## COMPANY STATEMENT

(Reference JVM410 midi connections on product)

### Condition

Ground loop hum detected when connecting the JVM410 to multiple effects set-ups with MIDI.

Cut DGND pin at SK2 pin 2 as shown

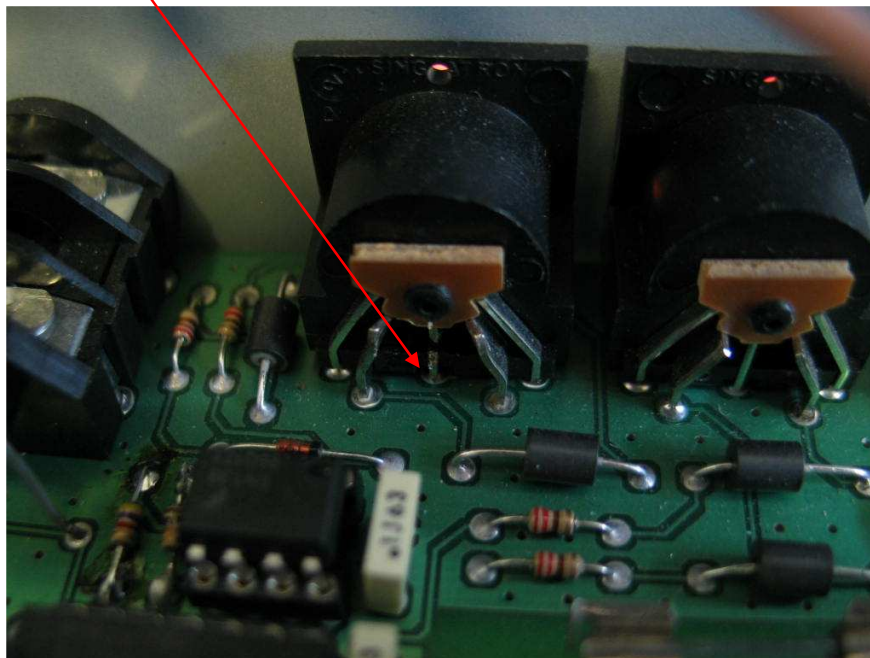
PCB number JVM410-60-00, issue 1 & 2 are affected (issue 3 is good and unit should not suffer from hum).

PCB Issue 1 & 2 are affected and so the following action should be taken:

Remove DGND connection from pin #2 of SK2 DIN socket (MIDI IN). This leaves that pin unconnected which is fine.
